Subject: MHI's Response to US-APWR DCD RAI No. 815-5986 Revision 3 (SRP 06.03)

Response to Request for Additional Information
No. 815-5986 Revision 3

RAI NO.: NO. 815-5986 REVISION 3
SRP SECTION: 06.03 – Emergency Core Cooling System
APPLICATION SECTION: 6.3
DATE OF RAI ISSUE: 8/23/2011

QUESTION NO.: 06.03-102

Figure 1: RWSP Water Level Sketch

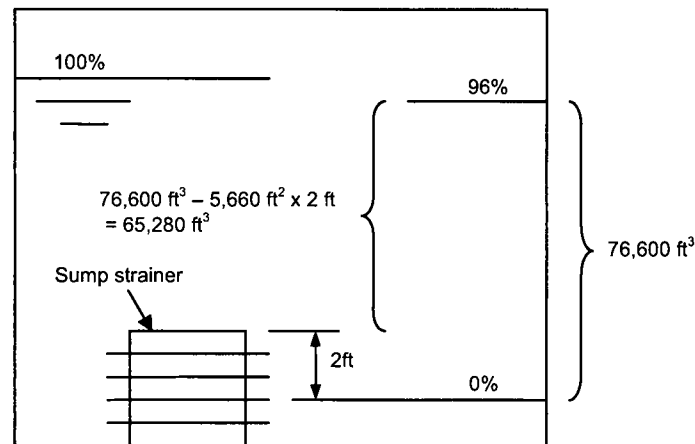
The calculation for the delay time for debris reaching the RWSP in Appendix E of MUAP-08013 Rev. 1 has the following seeming non-conservatisms: neglecting the RCS and accumulator volumes, the possibility of not filling or bypassing ineffective pools, the possibility of reduced return flow to the RWSP and the inclusion of minimum water level (margin for design basis). In light of these seeming non-conservatisms, justify the calculational methodology used for determining the delay time.

0% to 96% water level	76,600 ft ³	(Table 6.2.1-3 of Ref. 2)
0% water level to top of strainer	2 ft	(Figure 6.2.1-11 of Ref. 3 with Figure 2-1 of Ref. 1)
Effective area of RWSP	5,660 ft ² (8.15x10 ⁵ in ²)	(Table e-1 of Ref. 4)
Tech Spec minimum water level	96 %	(Ref. 3)
Strainer suction flow (4 train total)	15,960 gpm = 35.56 ft ³ /sec

Water volume between top of strainer and Tech Spec minimum level:

$$V = 76,600 \text{ ft}^3 - 5,660 \text{ ft}^2 \times 2 \text{ ft} \\ = 65,280 \text{ ft}^3$$

Debris transportation time:

$$T = 65,280 \text{ ft}^3 / 35.56 \text{ ft}^3/\text{sec} = 1835 \text{ sec}$$

Although the calculated delay time for the generated debris to reach the reactor vessel is approximately 1,800 seconds as discussed in Section 4, 850 seconds was adopted for the downstream evaluations to account for uncertainties.
